STAFF REPORT
COMMUNITY DEVELOPMENT DEPARTMENT

SUBJECT: FP-2023-0001
Friendship Subdivision - FP

LOCATION: 6168 Elk Ranch Lane in the Northeast
1/4 of the Northwest 1/4 of Section 30,
T.4N., R.1E.

B. Final Plat (dated: 1/24/23)

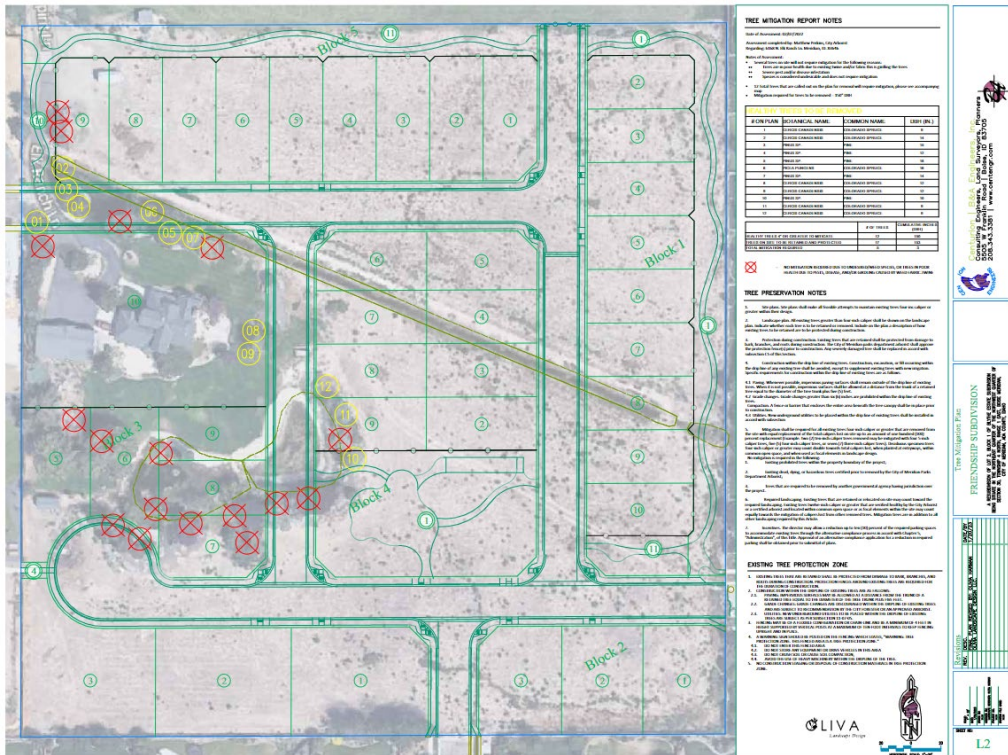
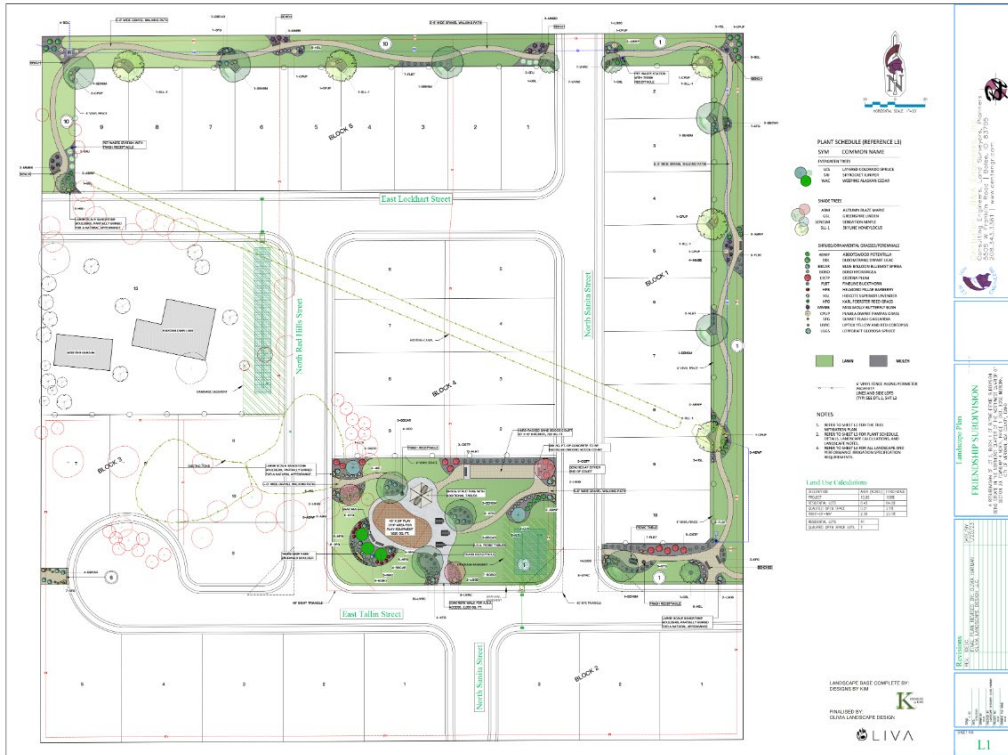
3. Prior to submittal for the City Engineer's signature, have the Certificate of Owners and the accompanying acknowledgment signed and notarized.
4. The final plat prepared by Centurion Engineers, Inc. stamped by Joseph D. Canning, dated: 1/24/2023, included in Section V.B shall be revised as follows:

- a. The existing irrigation easement bisecting the property is to be relinquished and replaced with a new easement as depicted on the submitted plans, prior to signature on the final plat.

- b. Note #2: Include the recorded instrument of the Friendship Subdivision Homeowners' Association Master Declaration of Covenants, Conditions, and Restrictions on the recorded plat.

- c. Revise Note #5: "Lots shall not be reduced in size without prior approval from the health authority and the City of Meridian."
 - d. Replace Note #10: with "the subdivision is subject to the existing Development Agreement and include the DA instrument number (DA Inst. #2022-045751)."

- e. Note #14: Include the recorded instrument number of the ADA County Highway District easement.
 - f. Note #15: Include the recorded instrument number of the ADA County Highway District easement.
